# Proposed reference equalizer change in Clause 124 – updated results.

P802.3bs SMF ad hoc

# Comment r01-21 against IEEE P802.3bs D3.1.

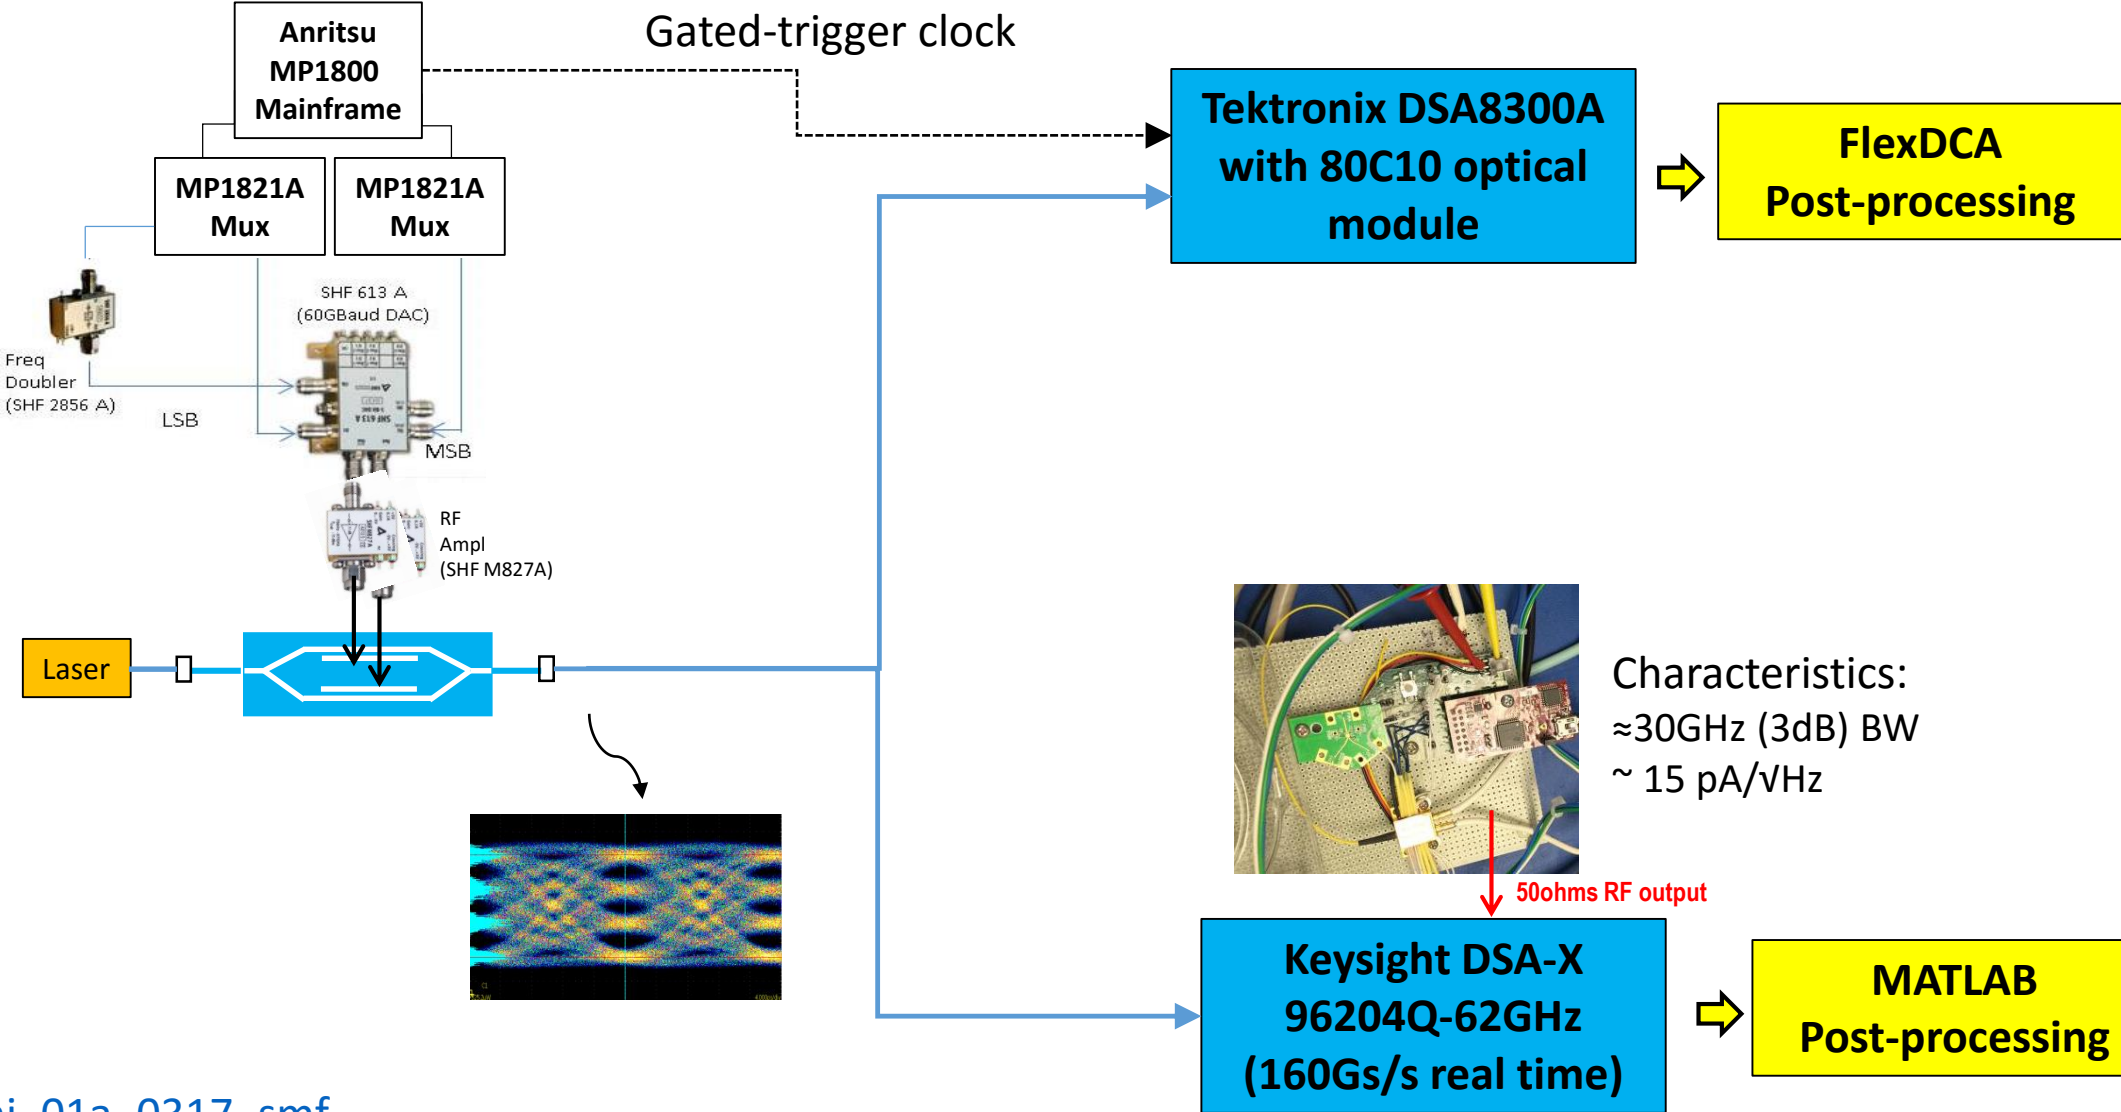
**Change from:** The TDECQ of each lane shall be within the limits given in Table 124-6 if measured using the methods specified in 121.8.5.1, 121.8.5.2, and 121.8.5.3 using a reference equalizer as described in 121.8.5.4, with the following exceptions:

- The signaling rate of the test pattern generator is as given in Table 124-6.
- The combination of the O/E converter and the oscilloscope has a fourth-order Bessel-Thomson filter response with a bandwidth of 38.68 GHz.

**Change to:** The TDECQ of each lane shall be within the limits given in Table 124-6 if measured using the methods specified in 121.8.5.1, 121.8.5.2, and 121.8.5.3 with the following exceptions:

- The signaling rate of the test pattern generator is as given in Table 124-6.
- The combination of the O/E converter and the oscilloscope has a fourth-order Bessel-Thomson filter response with a bandwidth of 38.68 GHz.
- The reference equalizer is a 5 tap, T spaced, feed-forward equalizer (FFE), where T is the symbol period.

NOTE-This reference equalizer is part of the TDECQ test and does not imply any particular receiver equalizer implementation
